## **Reindeer Project Construction Services, Savoonga** EDA Project Number 07 79 07873

### **Addendum #5** 7/19/2024

Summary of items included in this addendum:

1. (Updated) List of questions received during solicitation period and answers
  - pg. 2-4
2. (Updated) Architectural Sheet A-601
  - pg. 5
3. (Updated) Structural Sheets S-101, S-102, and S-501
  - pg. 6-8

**S-102**

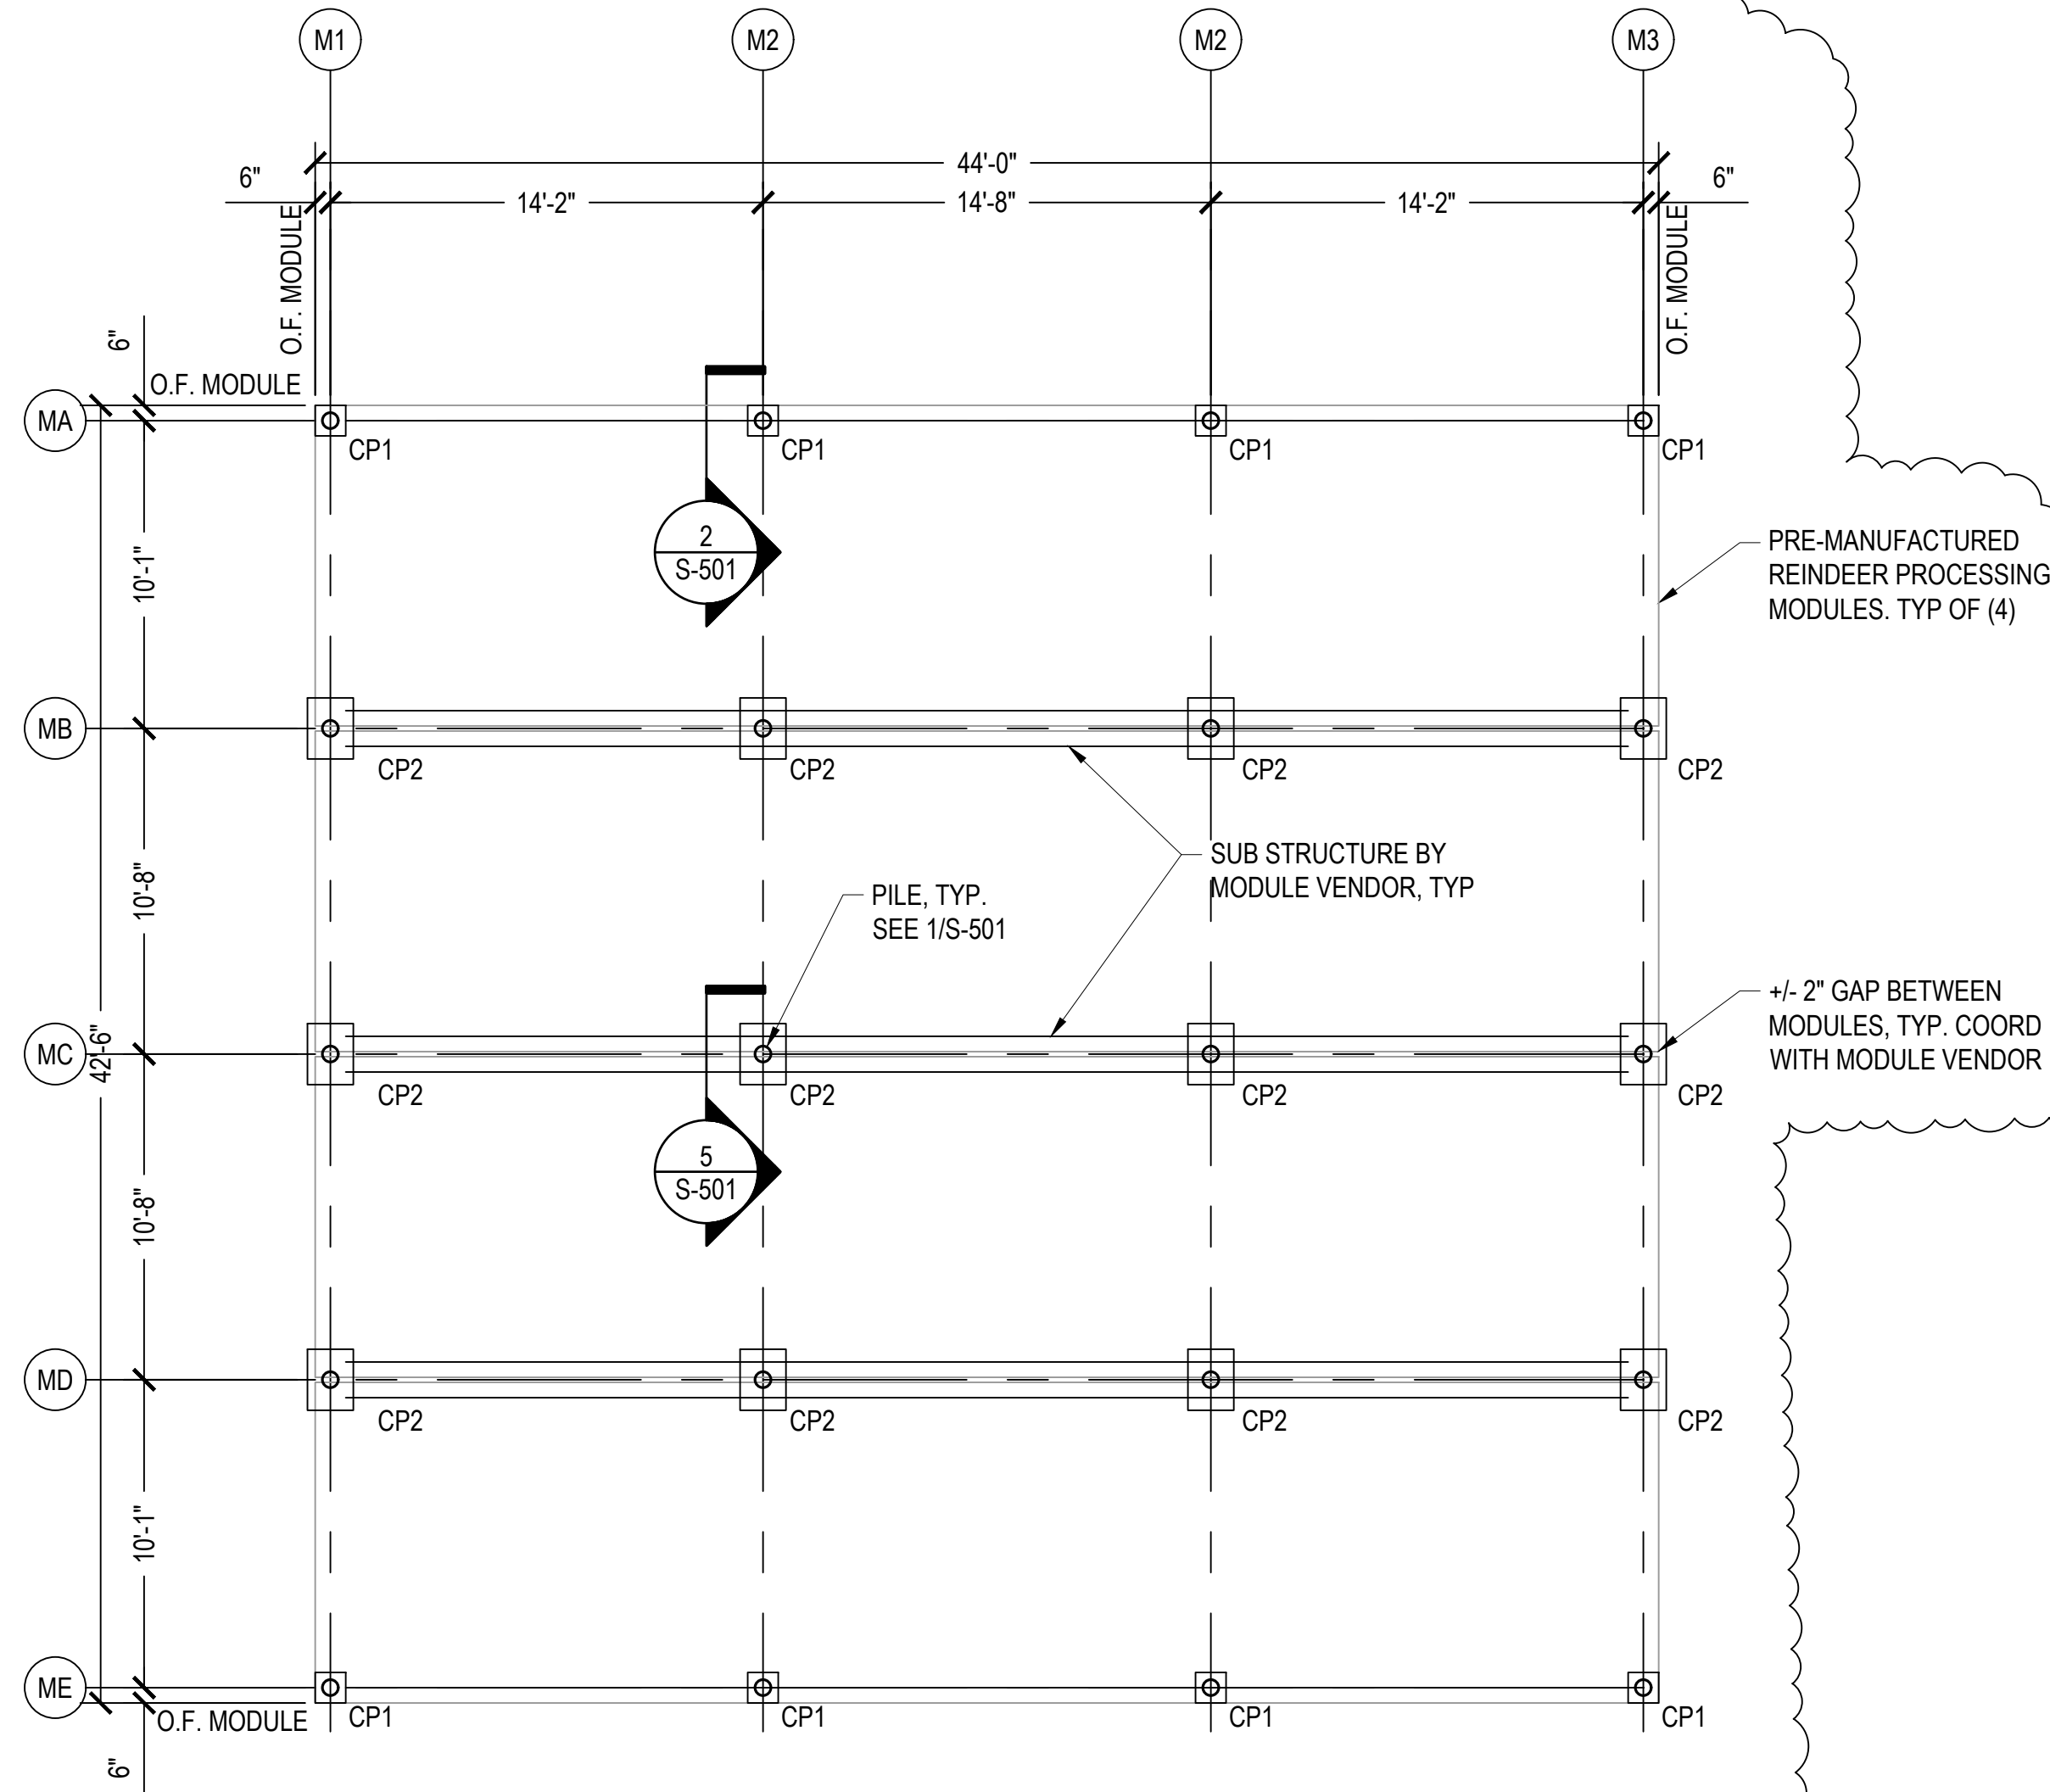
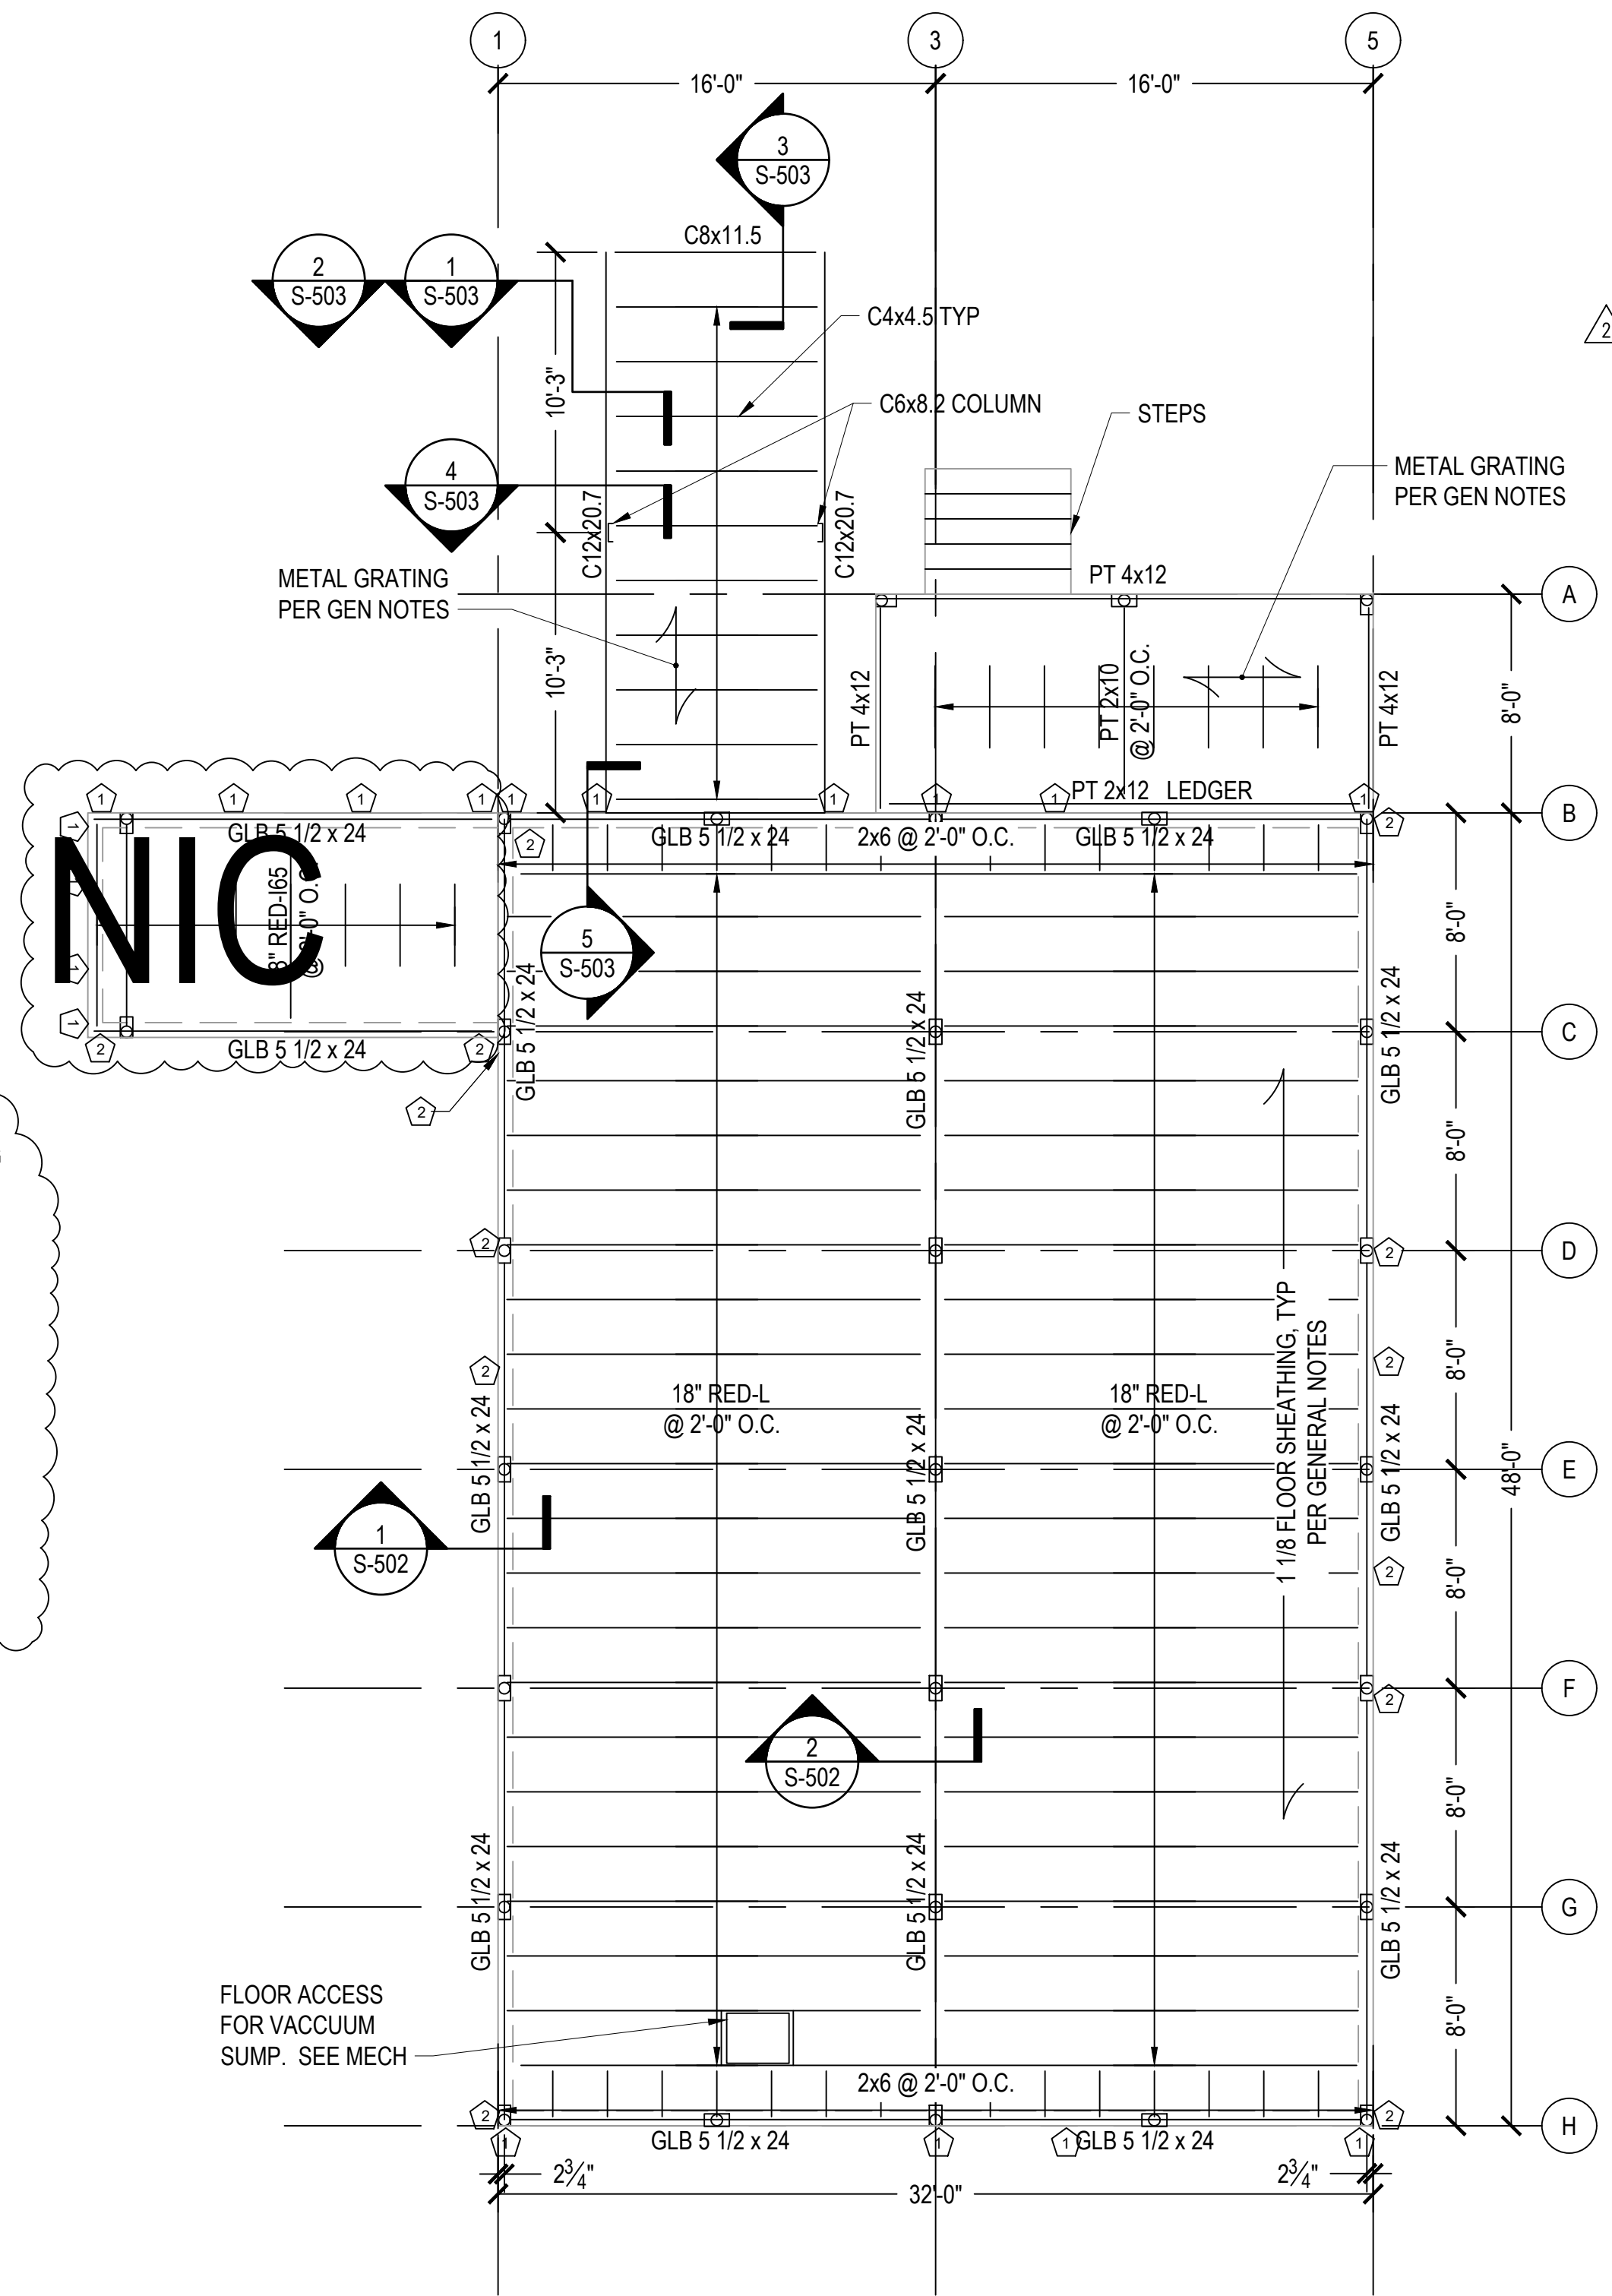
6	Please provide modular connection details. (Structural, roofing and siding details)	Refer to updated structural sheet(s), issued as part of addendum #5, for structural connection details. Refer to Exhibit A, issued as part of addendum #4, for General Contractor's involvement in roofing installation. Module exteriors are prefinished by the manufacturer and do not require siding to be installed.
7	Please confirm if the Water & Sewer Mains utilidor will be supplied and installed by others. See sheet C-200, detail 2	All water and sewer main utilidors shall be furnished and installed by the general contractor. C-200 has been updated to remove "by others" and is included in addendum #1.
8	On the Room Finish Schedule on A-601, please confirm that FRP panels are to be installed for the flooring in the bathroom.	Sheet A-601 has been revised to include clarifications to the room finish schedule and finish schedule abbreviations. The revised A-601 sheet is included in addendum #1.
